**SITE PLAN REVIEW SHEET
ENVIRONMENTAL VARIANCE REQUEST ONLY**

CASE: SP-2017-0478D

PROJECT NAME: All Stor Westlake

The applicant requests to vary from LDC 25-8-342 Fill Requirements to allow fill up to 11 feet.

ALL STOR WESTLAKE
9201 FM 2244, AUSTIN TX 78746
FILL EXHIBIT

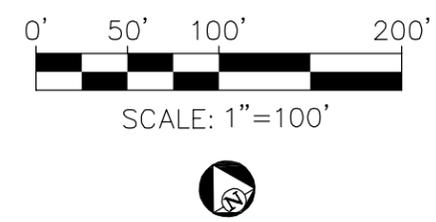
Yes The variance is required in order to provide access to an otherwise developable site. The only possible access, which is from Bee Caves Rd., must cross slopes exceeding 15 percent in grade. LDC 25-8-301 allows a person to construct a driveway on a slope with a gradient of more than 15 percent if it is necessary to provide primary access to at least two contiguous acres with a gradient of 15 percent or less. According to the applicant's engineer, this site meets these conditions.

However, in order to make the access and parking compliant with ADA slope requirements, fill exceeding 4 feet is necessary.

Yes The fill is required to provide ADA compliant parking and access to the building and to provide a fire lane along the east side of the building as required by fire code.

Yes The current layout is the minimum deviation from code requirement that could accommodate the required fire lane.

Yes The fill for the fire lane is upslope of the building foundation, which will stabilize the fill. Fill for the parking will be stabilized by a four and a half foot retaining wall that will be constructed before the fill is placed.

The findings of fact have been met and staff recommends approval.

STAFF DETERMINATION: Staff determination is that the findings of fact have been met. Staff recommends the following condition: that the applicant provide a landscape plan, which is not required in the ETJ.
